Intel[®] 80331 I/O Processor

Specification Update

April 2006

Order Number: 273930-021US

Table 236. DDR SDRAM Control Register 0 - SDCR0 (Sheet 1 of 2)

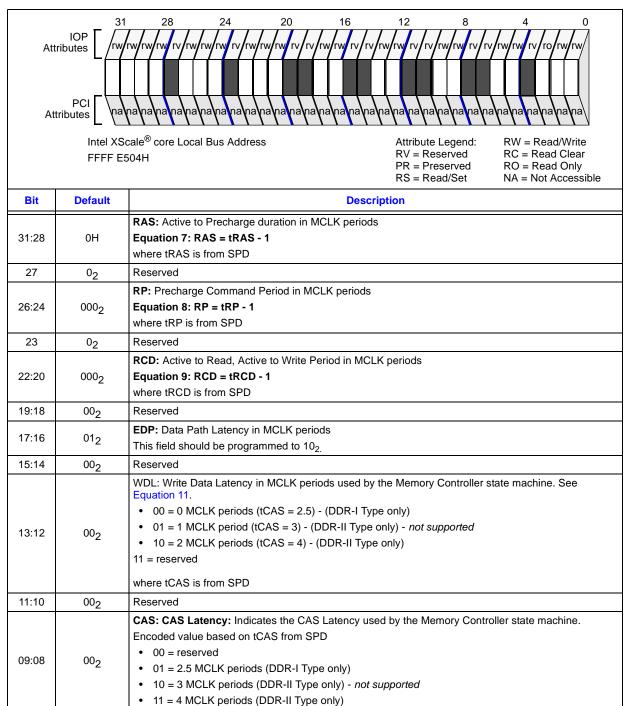
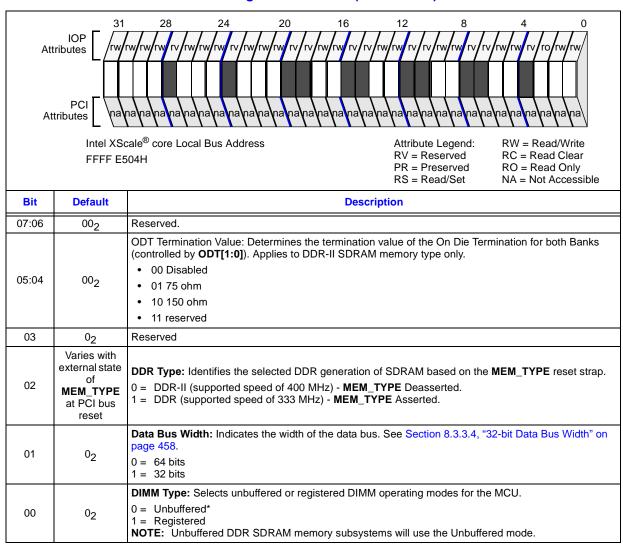
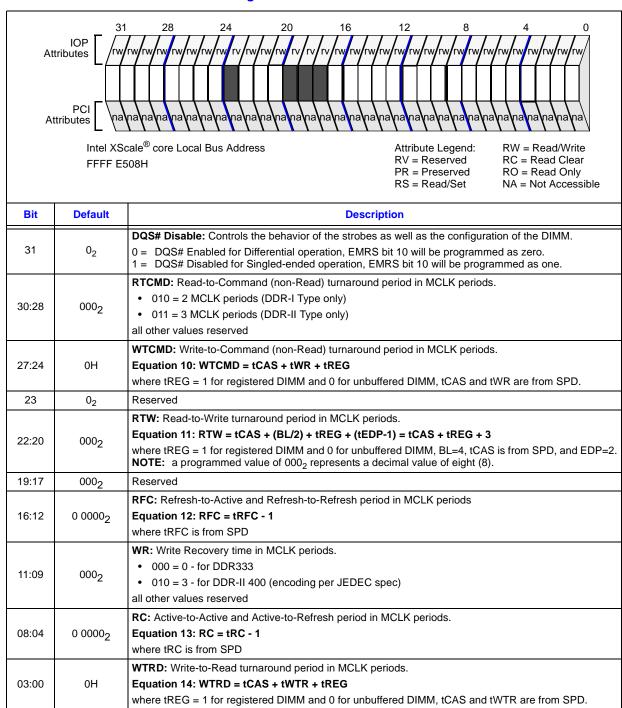
Workaround:
